PHOENIX HOMES

NEWINGTON M – 2021

**Re: Proposed Single Family Dwelling, 108 Frank Fisher Crescent, Lot # 135 White Tail Ridge, Almonte,
Kollaard Associates File # 230020**

With regard to structural issues only, Kollaard Associates has reviewed the following drawings:

SECOND FLOOR PLAN (ELEVATION M)
1672 SQ. FT.

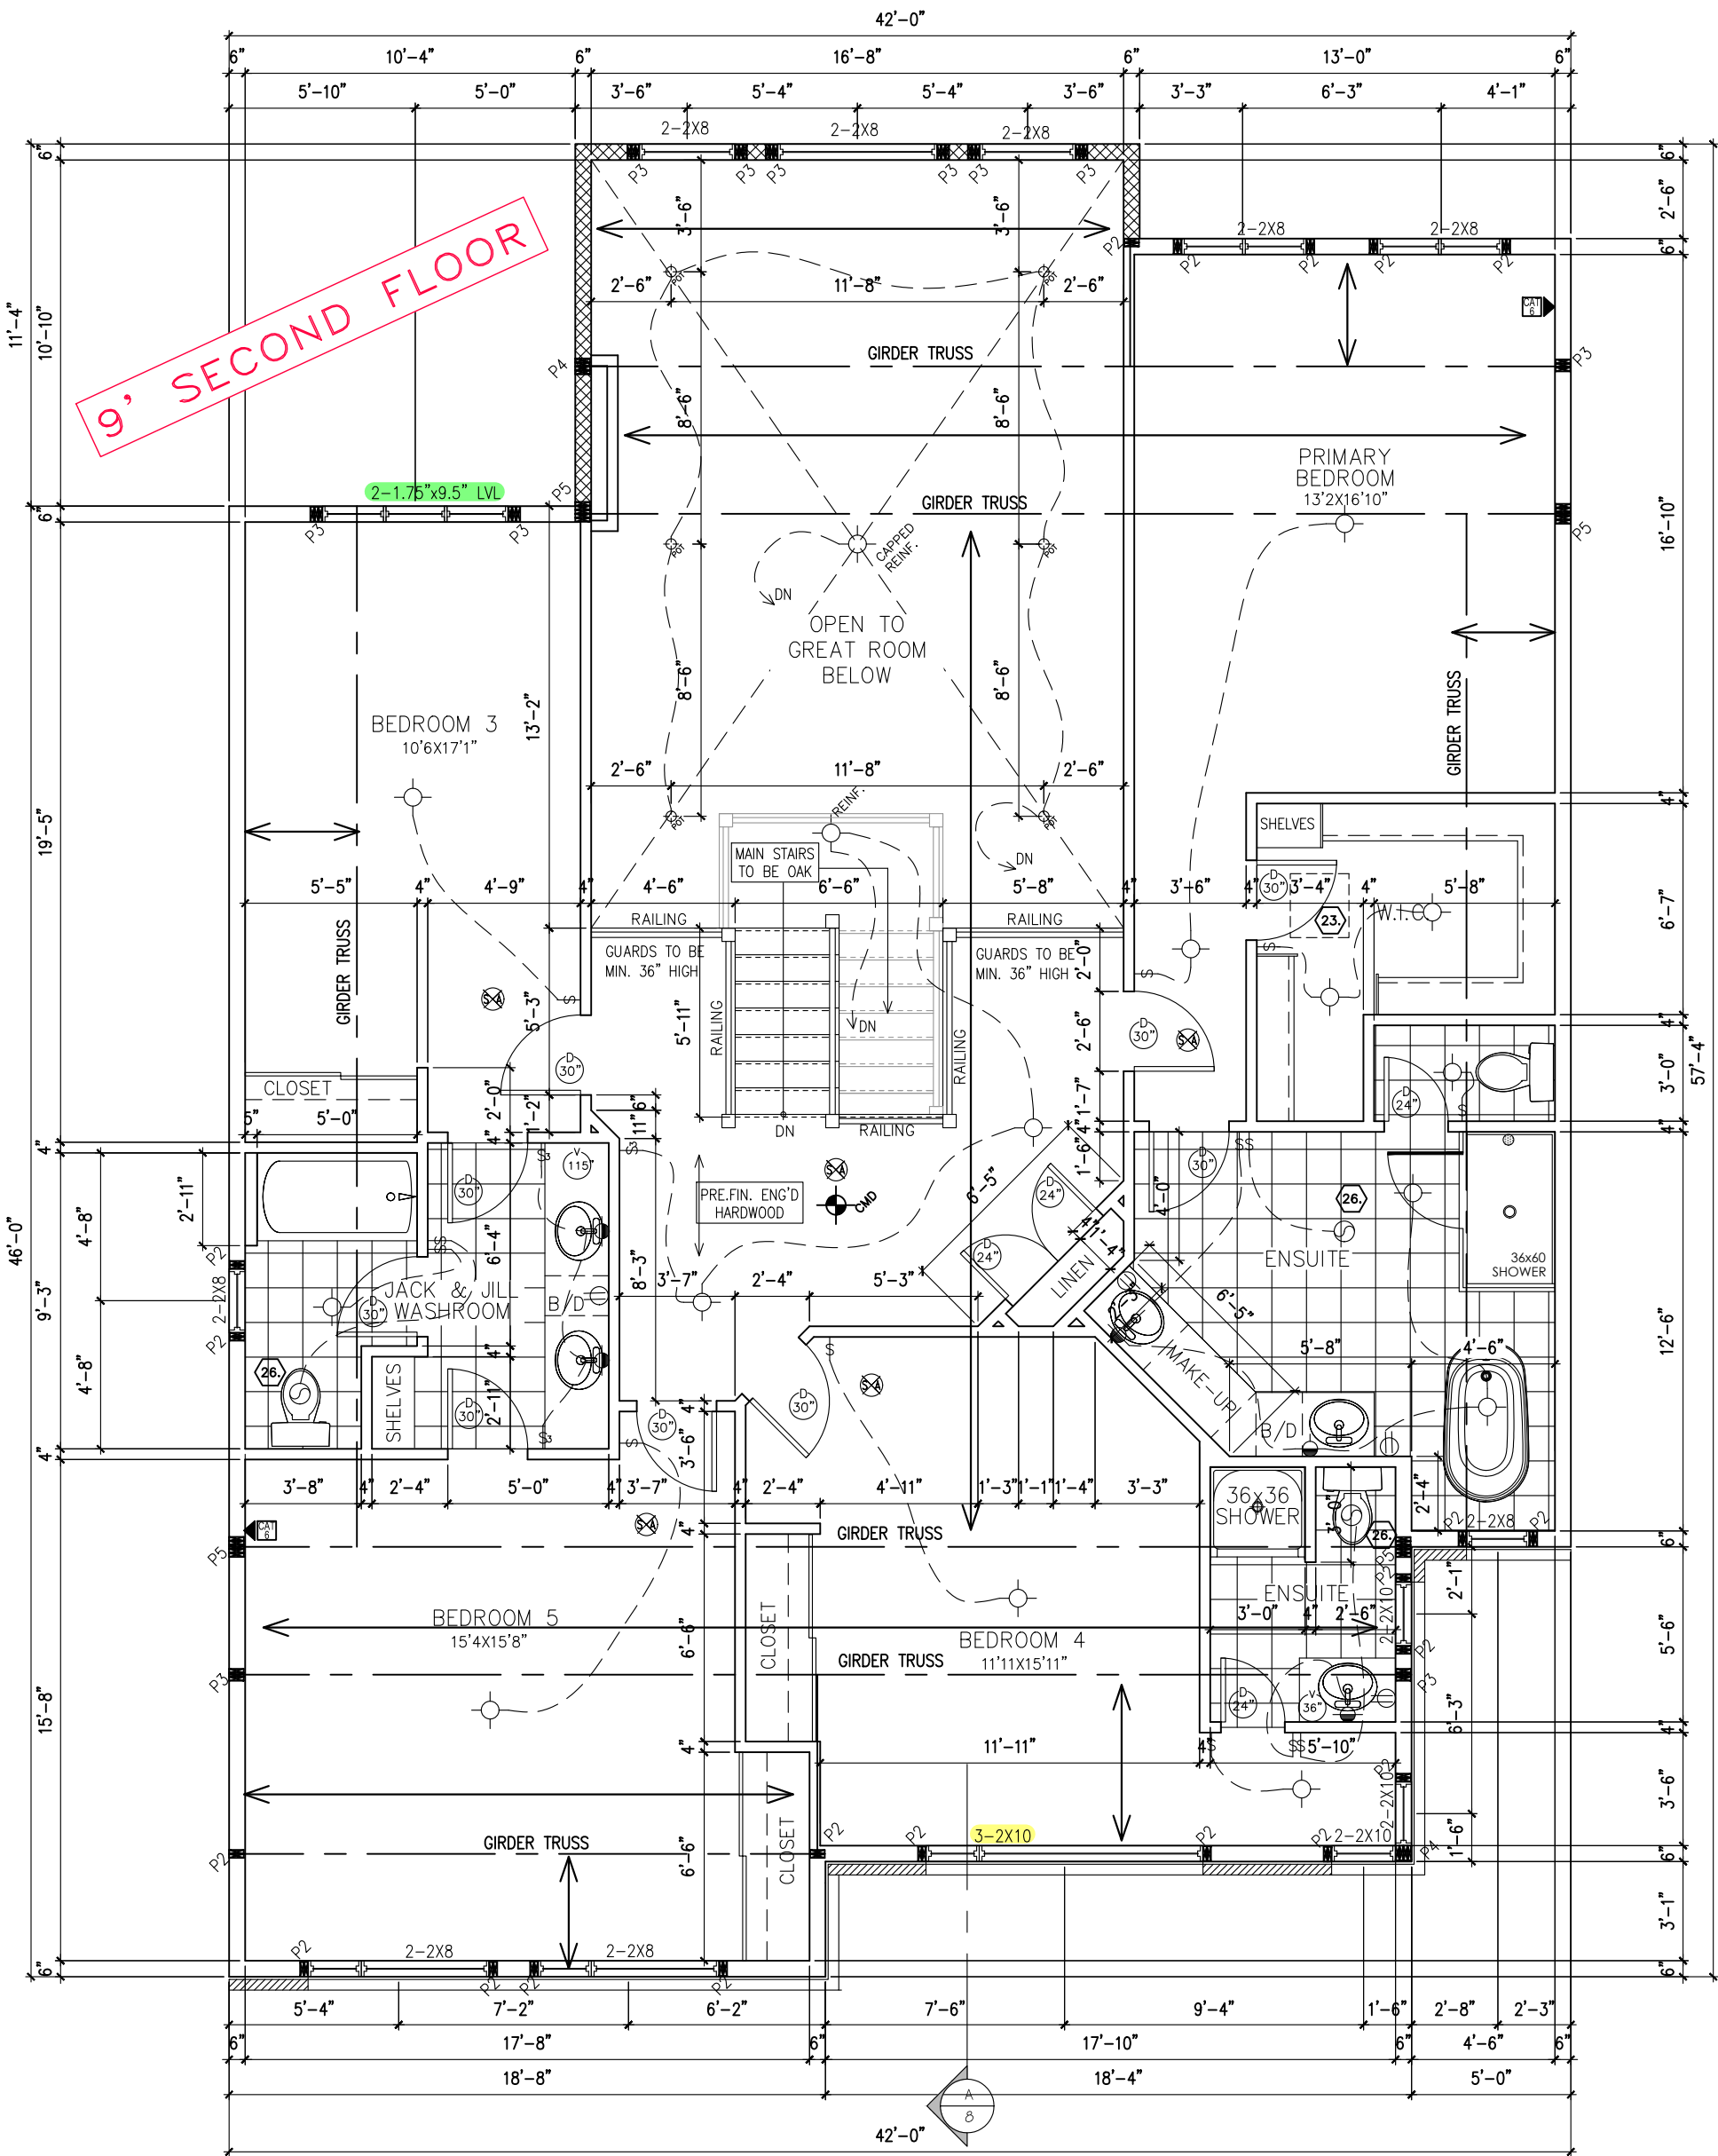
Second Floor Plan – Pages # 4M:

1. It is the opinion of Kollaard Associates that the proposed lintels and supporting posts shown on Phoenix Homes Pages # 4M are adequate.
2. The proposed tall wall noted on Phoenix Homes Pages # 1 is adequate.
3. Posts supporting girders may consist of built up 2x6 posts as indicated on Phoenix Homes Pages # 4M and are laterally supported by plywood or OSB sheathing (i.e. posts form part of sheathed exterior walls unless noted).
4. Truss design is by others.

SECTIONS ELEVATION M

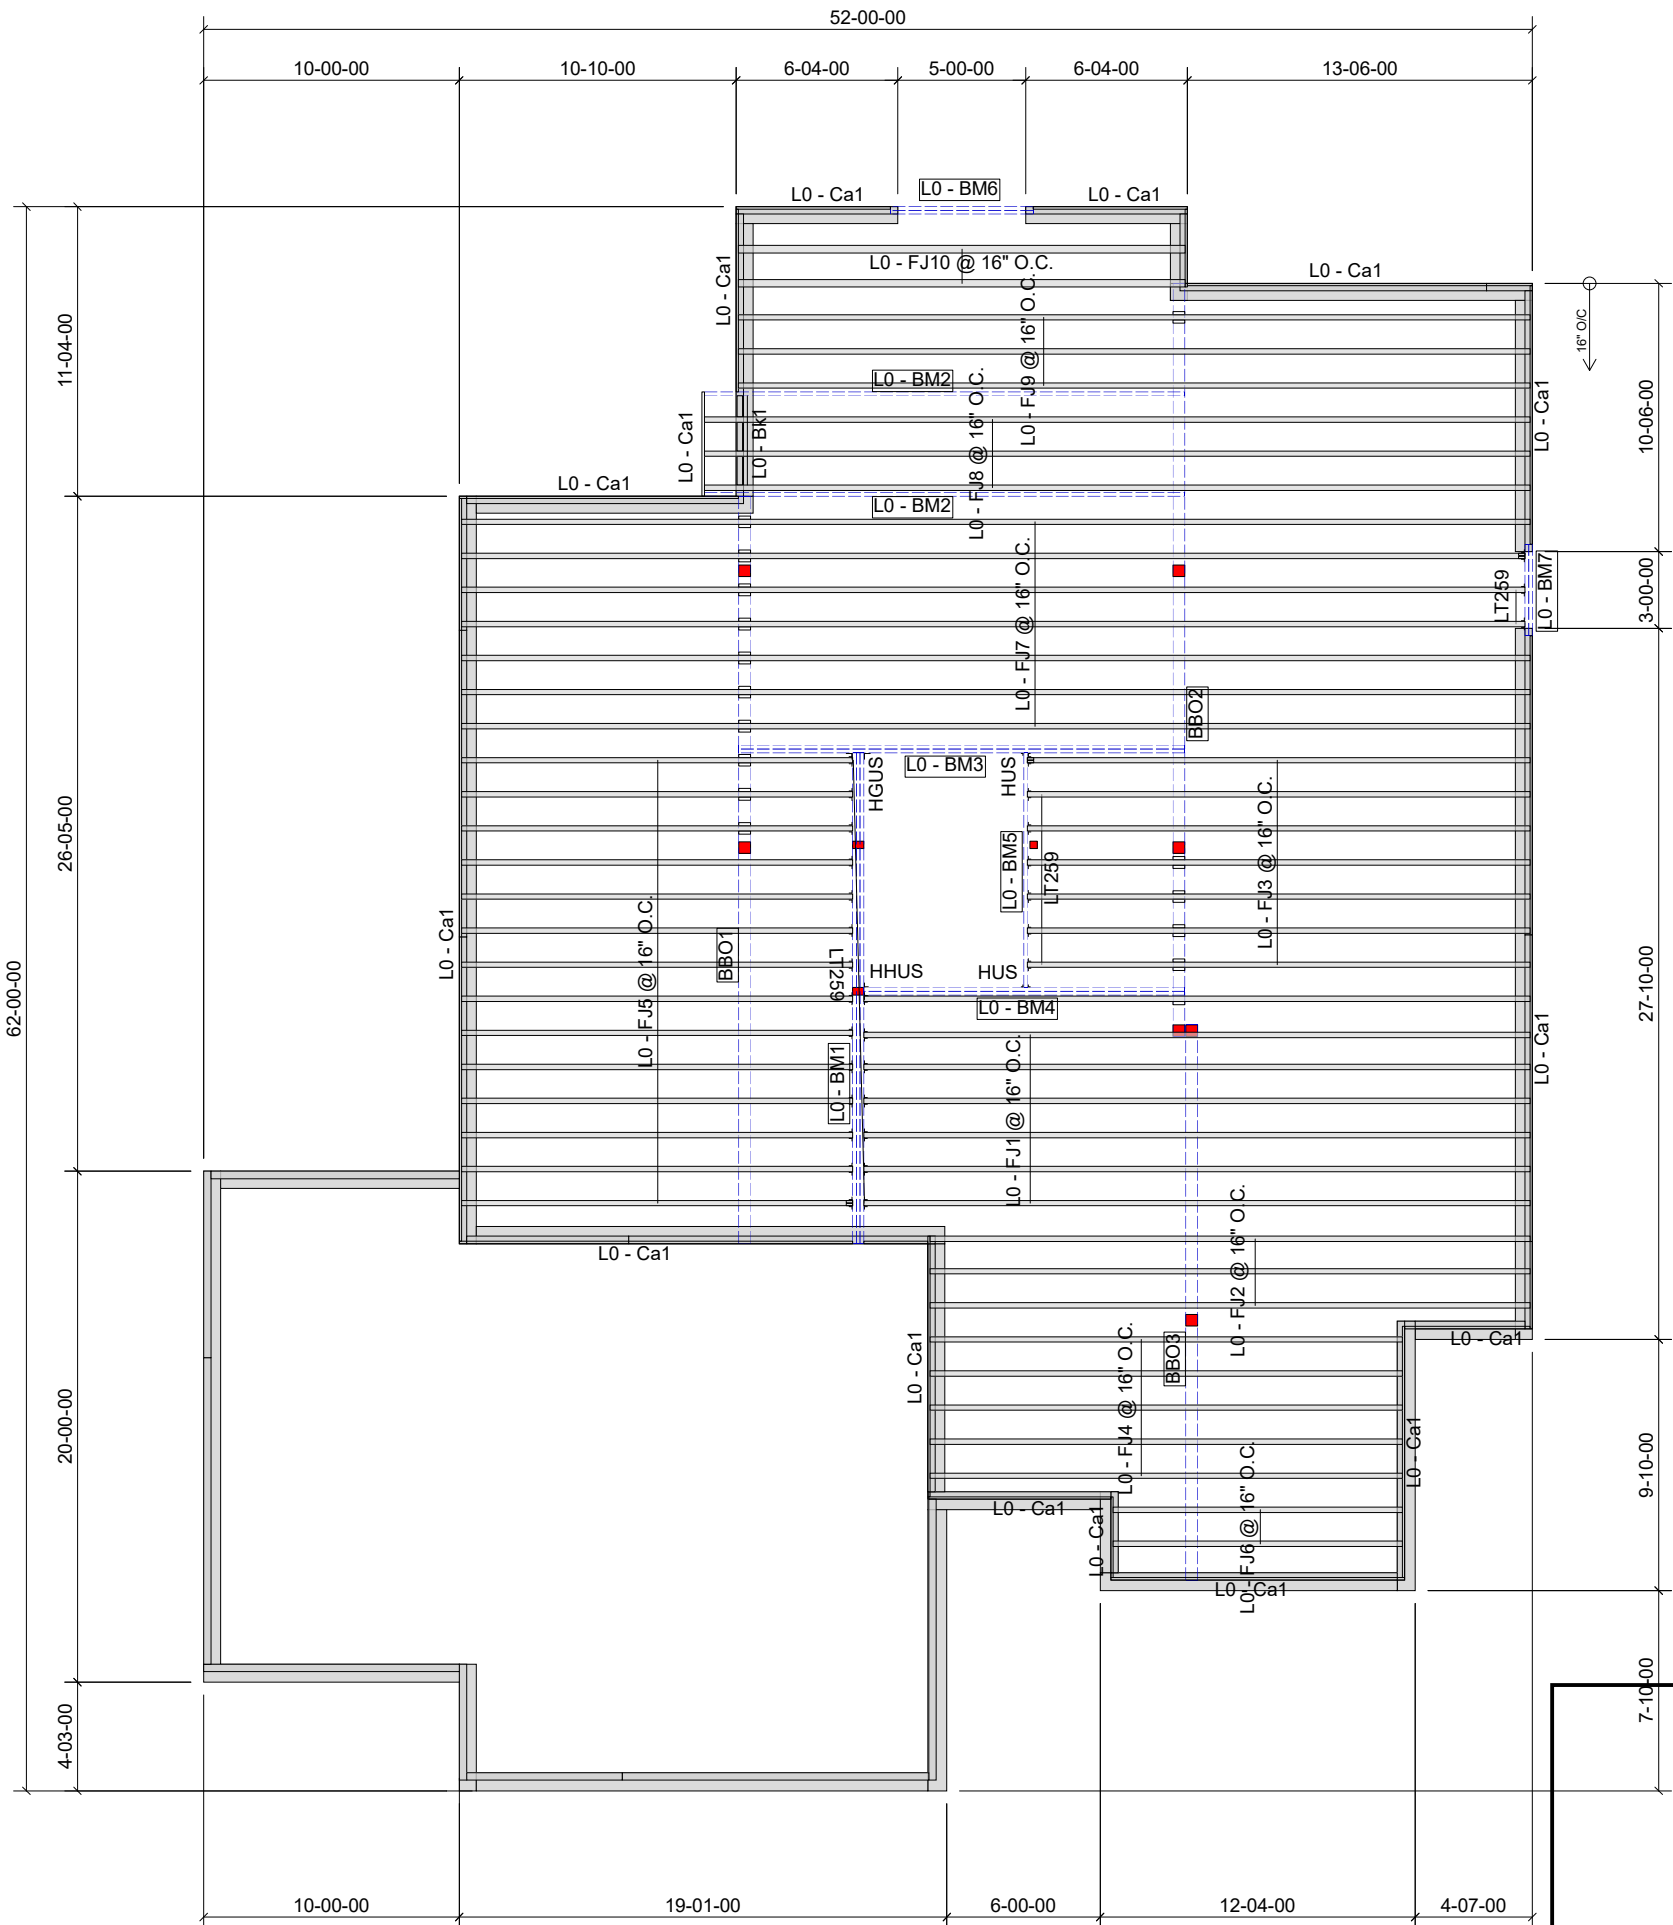
6. Ramset a 2x6 to the top flange of all steel beams to attach the above framing, floor joists and flush LVL beams.
7. The proposed web packing of the steel beam detailed on Phoenix Homes Sheet # 9M is adequate.
8. The proposed single angle connection of two steel beams detailed on Phoenix Homes Sheet # 6M is adequate.
9. Posts supporting girders may consist of built up 2x6 posts as indicated on Phoenix Homes Pages # 3M and are laterally supported by plywood or OSB sheathing (i.e. posts form part of sheathed exterior walls unless noted).
10. Truss design is by others.
11. Floor joist design and flush LVL beams within the floor structure are by the manufacturer.
